DATE: June 26, 2023

ADDENDUM NO. 28

PROJECT NO. DGS C-0211-0005 PHASE 005
PROJECT TITLE - PA State Police Academy - Core Bldgs, BESO & Sitework
PROFESSIONAL:
SOM
7 World Trade Center
New York, NY, 10007

SHEET No. **FTU-A-652**

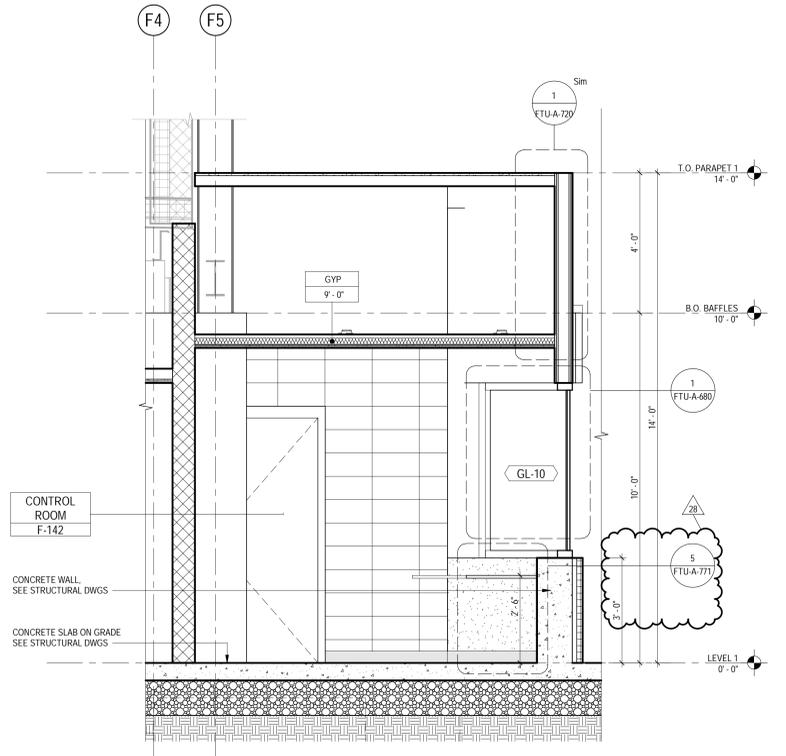
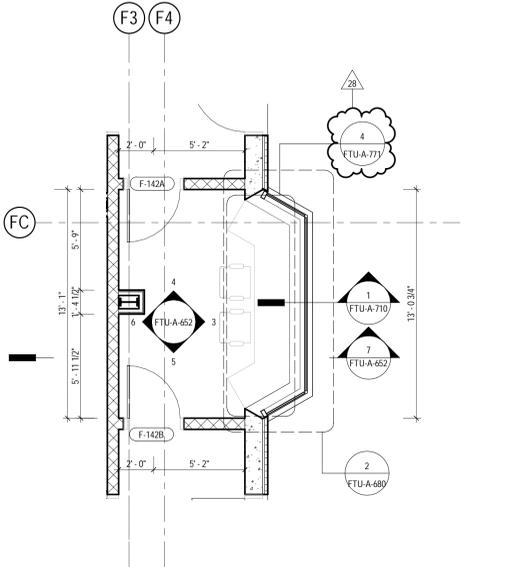
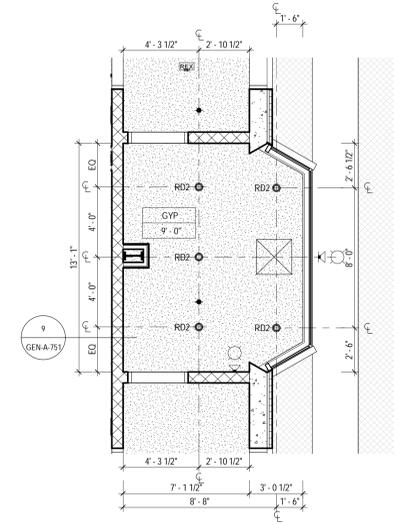
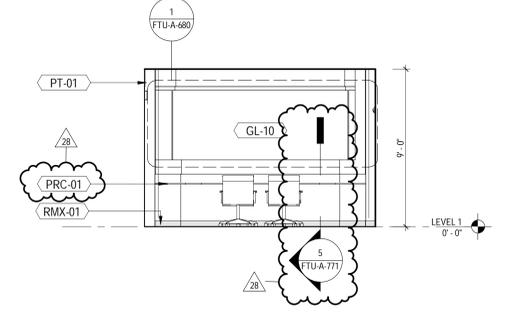
- Question 79: Please confirm F-142 Control Room in the FTU does not have any cabinetry or countertops and the table and chairs are part of the FF&E package.

- Response: FTU -Room F-124 Control Room has a millwork counter that is not part of FF&E. The chair in this room is part of the FF&E package. See revised sheets FTU-A-680, FTU-A-652, FTU-A-771, FTU-A-710.

SHEET No. GYM-A-750			
DRAWN BY	CHECKED BY	DATE	SCALE
ML	TNB	SEPT 2022	AS NOTED

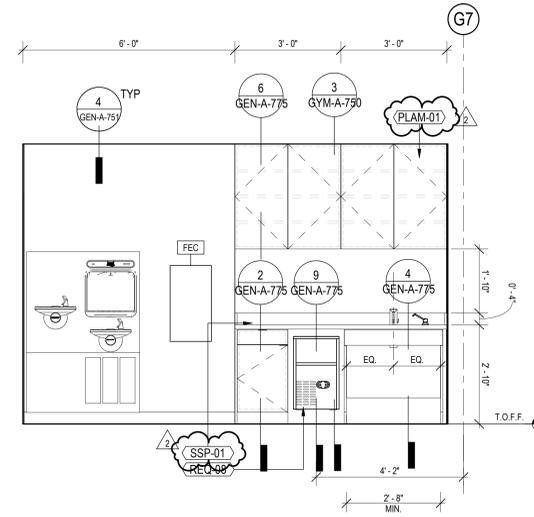
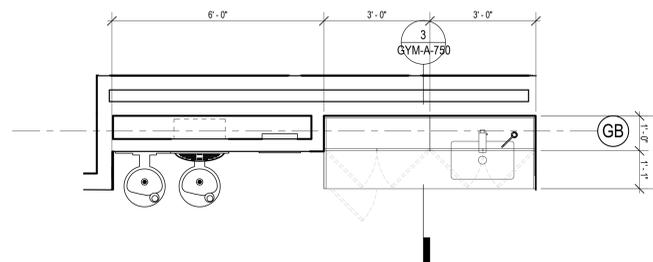
- Question 80: Interior elevation drawings 19/GYM-A-656 and 15/GYM-A-656 do not have countertops or cabinets labeled. Please advise.
- Response: Refer to revised GYM-A-656 and GYM-A-750 as issued in Addendum 28 clarifying material selections.

SHEET No. **MAQ-A-161**

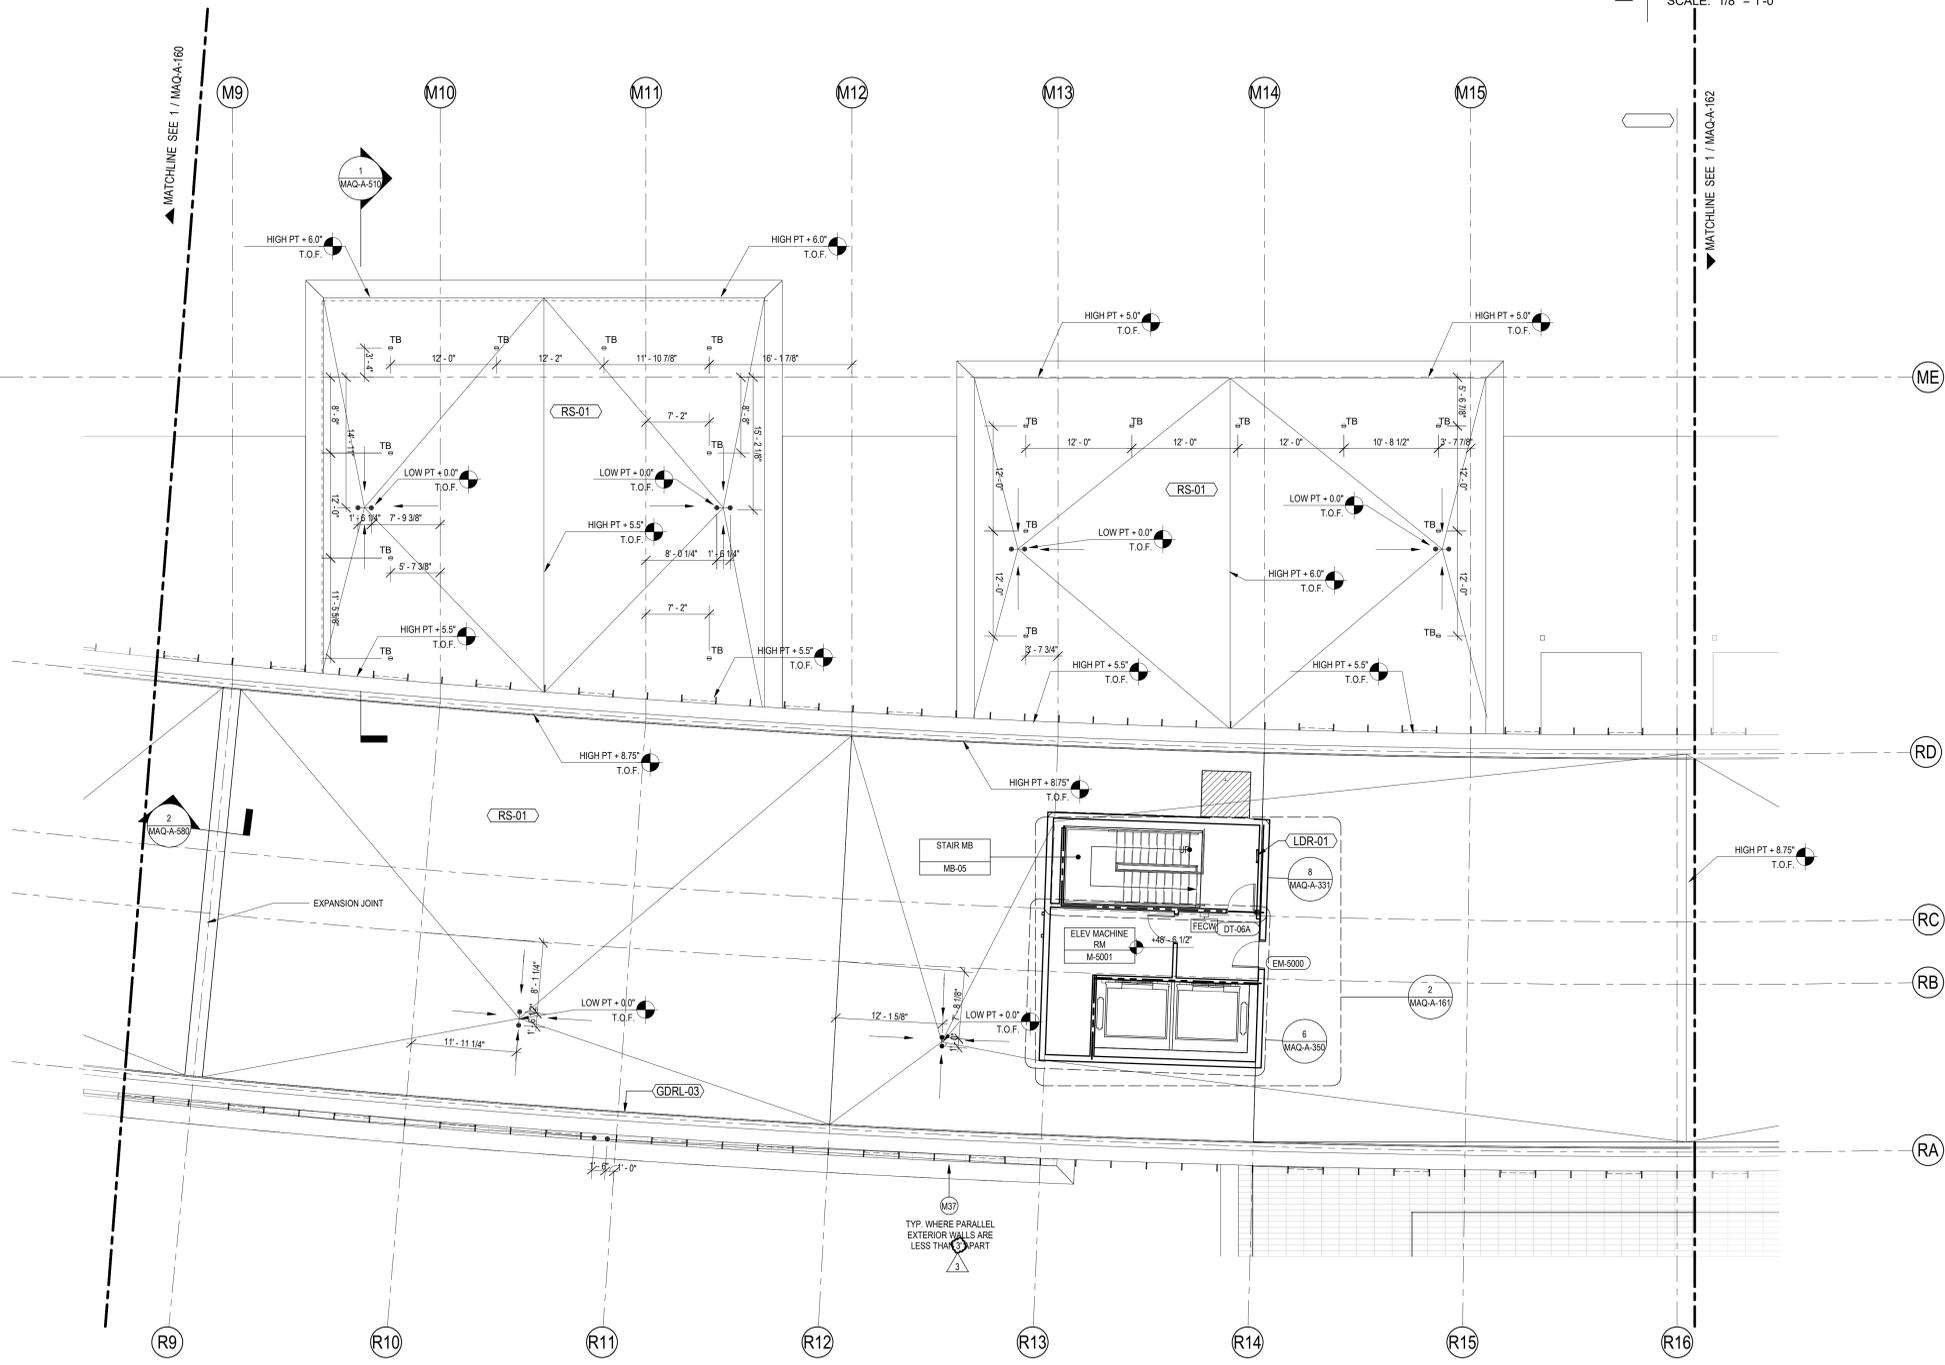
- Question 57: Please provide clear direction on the scope for bird control devices. Drawings MAQ-A-160/161 point to M37 which references bird control devices and notes that it is to be installed where two parallel exterior walls are less than 1' apart. However, the spot that is pointed to is more than 1' apart. It is not clear where and how much quantity of bird control devices are required.

- Response: BCD-02 to be provided on parapets where the gap between parallel exterior walls is less than 3'. Refer to revised note on MAQ-A-160 and MAQ-A-161 as issued in Addendum 28. Bird control devices are to be installed at the manufacturer-recommended frequency along the length of the parapet where indicated.

SHEET No. **MAQ-A-675**

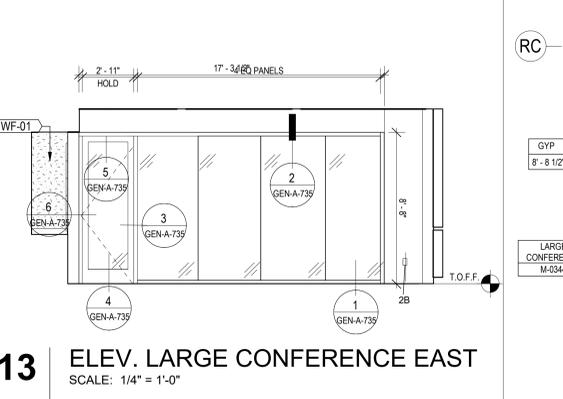
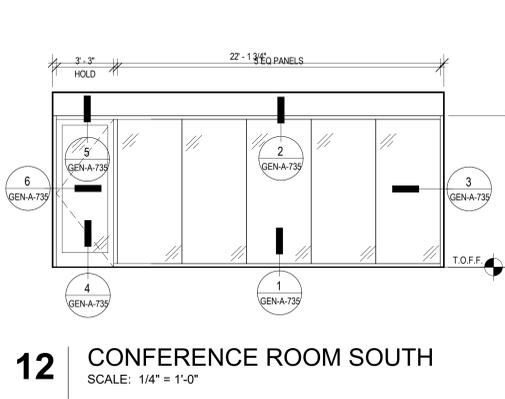
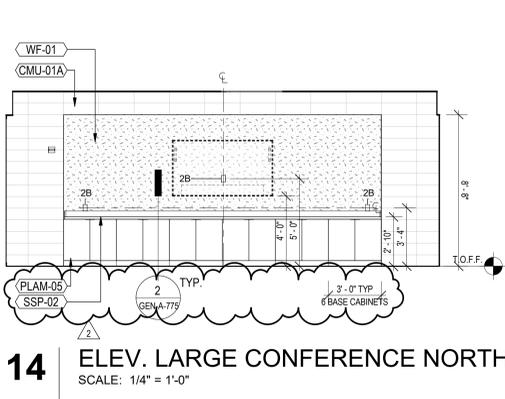
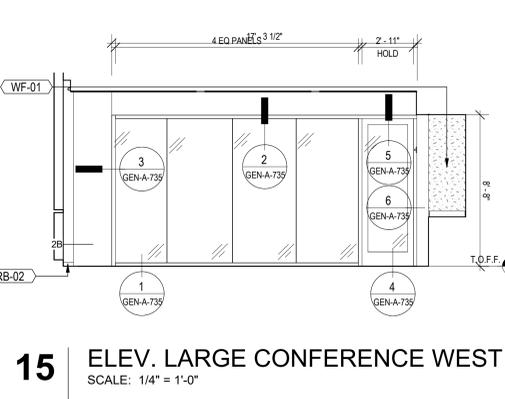
- Question 66: Conference Room M-0344 on MAQ-A-113 appears to show some kind of built-in casework on the plan north of the room however, elevation 14/MAQ-A-675 does not show anything regarding casework or countertops. Please clarify.

- Response: Refer to revised MAQ-A-675 as issued in Addendum 28 clarifying millwork scope in Conference Room M-0344.
- Question 67: Typical restroom vanity section detail 1/GEN-A-771 does not have a label for the ADA vanity panel nor do the MAQ restroom elevations. Please define the ADA vanity material. If the ADA vanity material is to be solid surface material, please detail the supporting structure.

SHEET No. **MAQ-E-501**

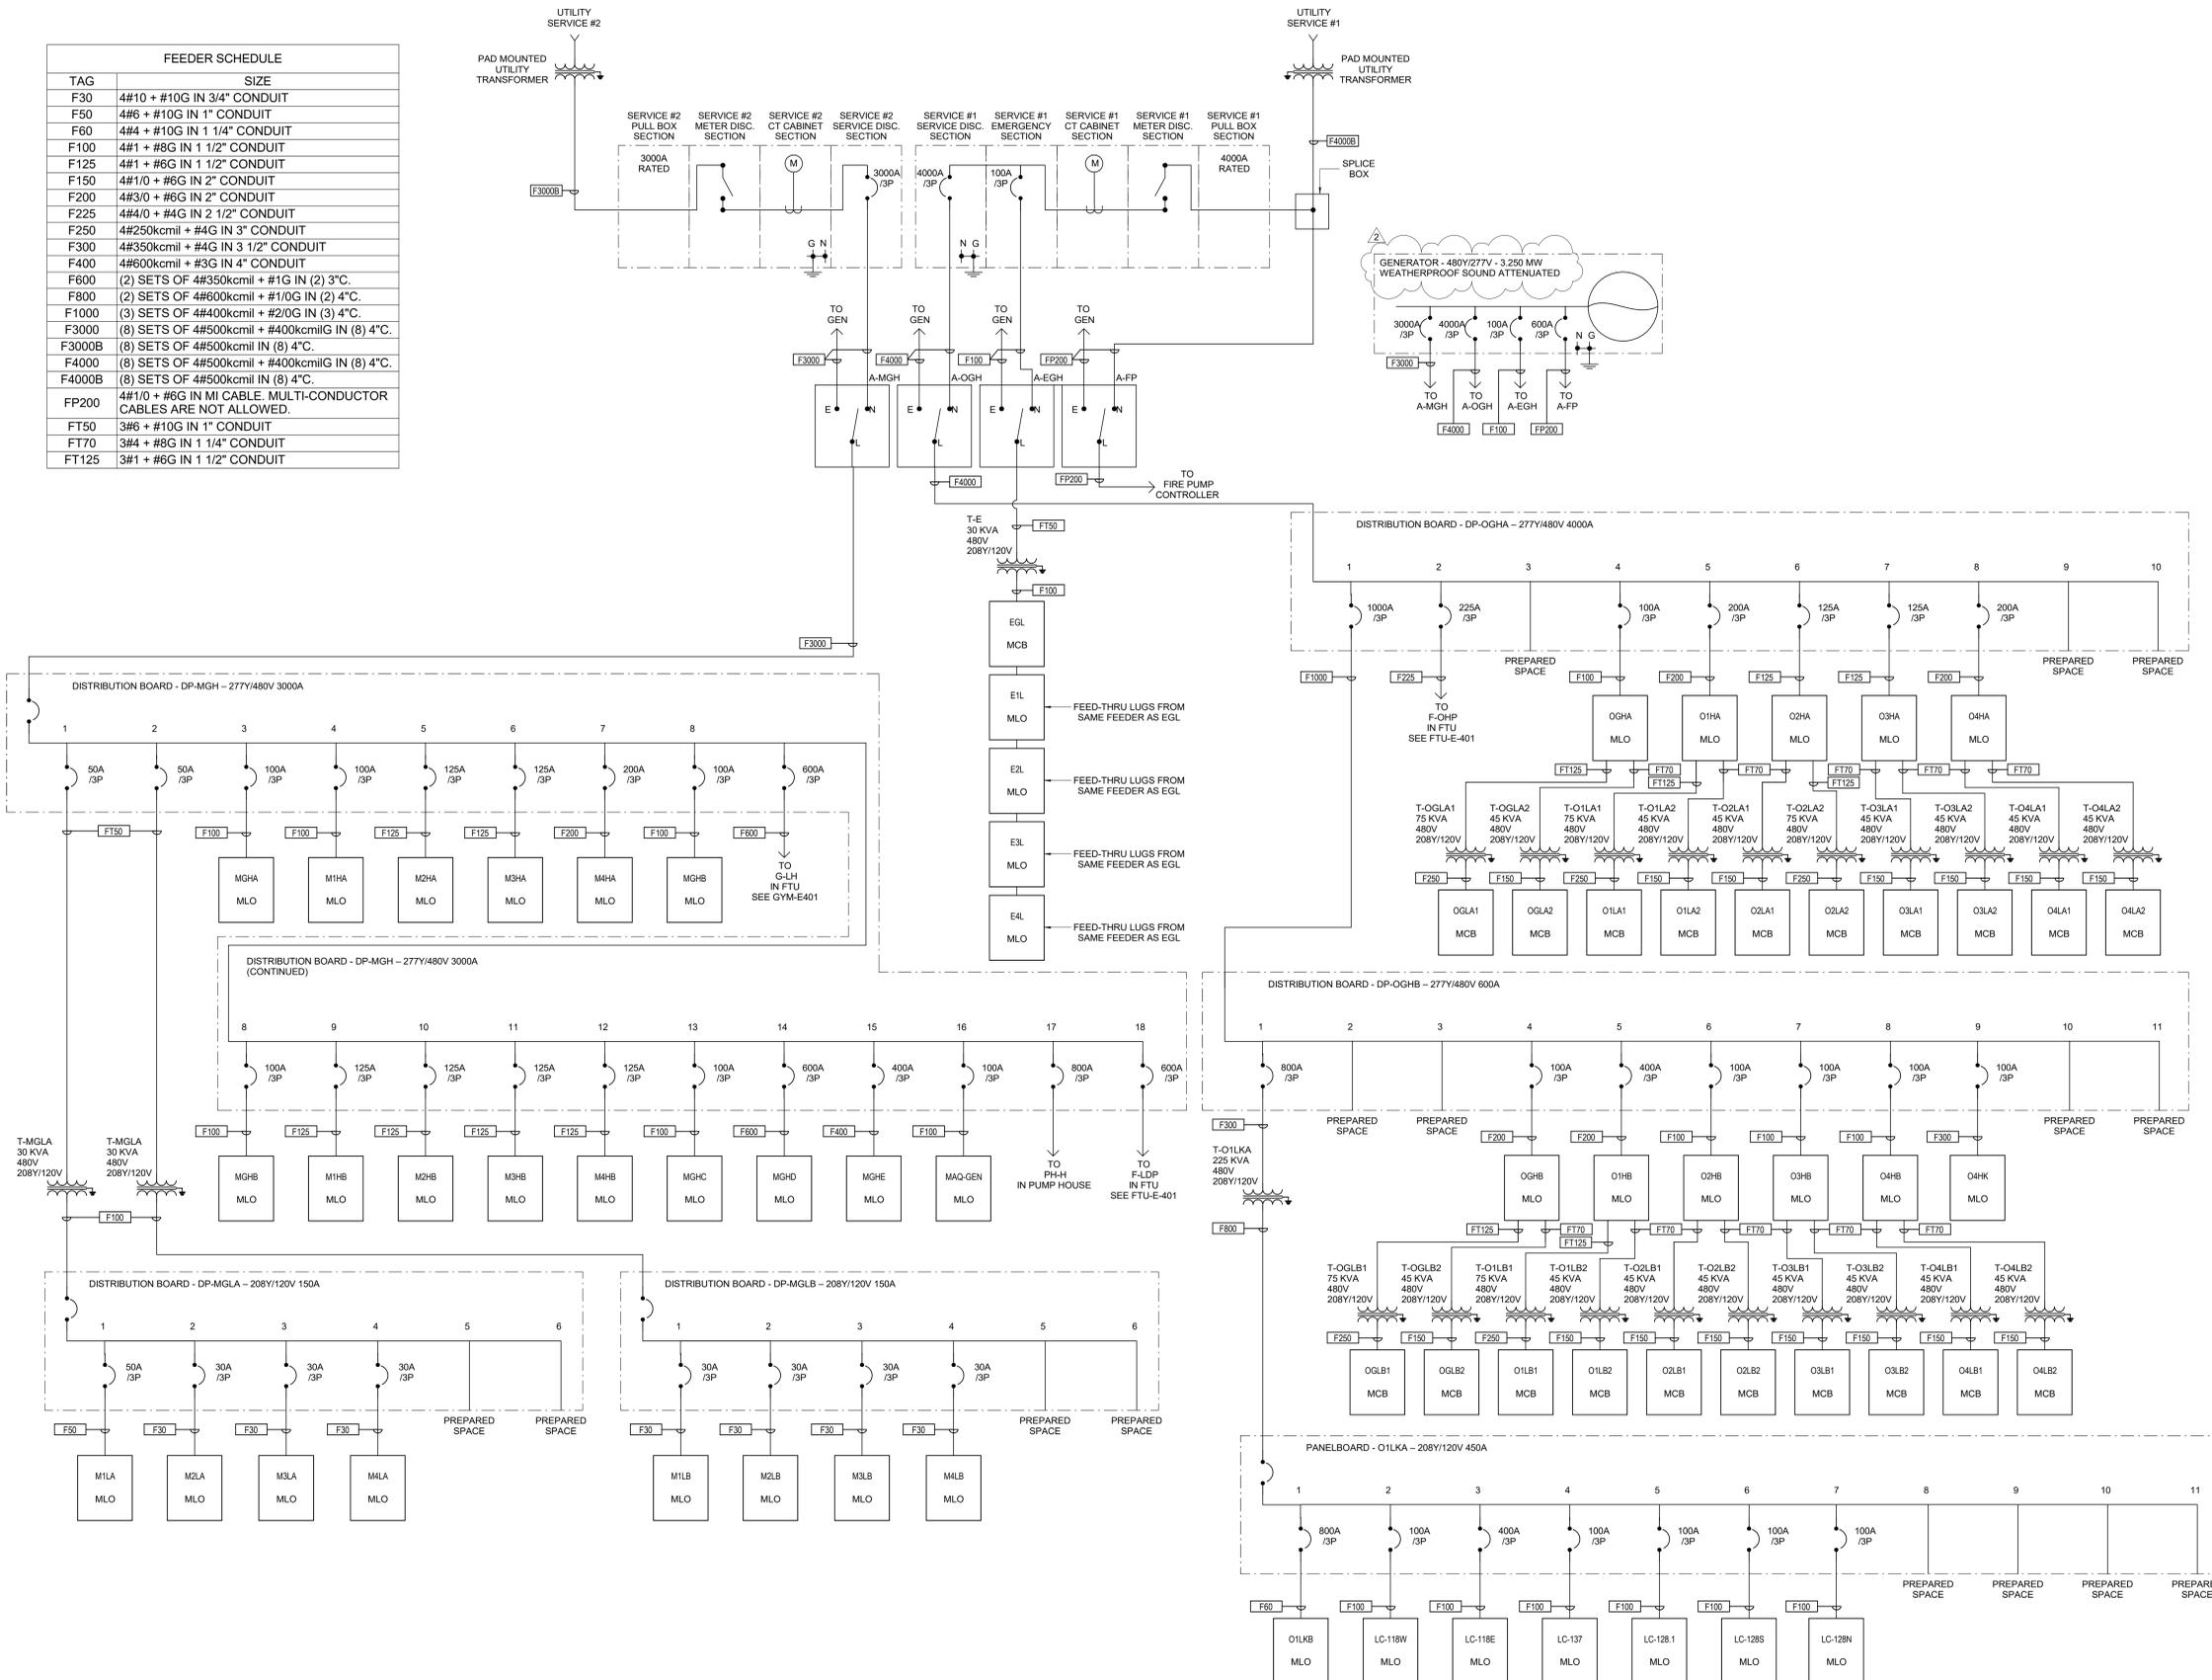
- Response: Refer to revised spec section 263213 and drawing MAQ-E-505 as issued in Addendum 28, modified to show belly tank only.
- Question 3: Spec section 263213, 2.2 list generator MAQ at 2800KW. Drawing MAQ-E-501 calls out 3125KW. Drawing MAQ-E-505 calls out a 3250KW. Please clarify the generator size.

- Question 6: Drawing MAQ -E-501 is the 1-line for the 3125KW genset. BSO-E-402 is the 1-line for the 750KW genset. Are there 1-line drawings showing the 320KW and 200KW generators listed in the specification or are these gensets not to be included? If they are to be included, how are both of these generators (320kw & 200kw) being fueled?

- Response: Refer to revised spec section 263213, drawing MAQ-E-501, and MAQ-E-505 as issued in Addendum 28 clarifying generator size.
- Question 4: Spec section 263213, 2.7 calls out 81.4dba at 23'. Drawing MAQ-E-505 calls out 75dba, and 80dba. Please advise free field dbA level at 23'.

- Response: Refer to revised spec section 263213, BSO-E-402 and MAQ-E-501 as issued in Addendum 28. Drawing MAQ-E-501 is the 1-line for the 3125KW genset and BSO-E-402 is the 1-line for the 750KW genset match revised spec section 263213.
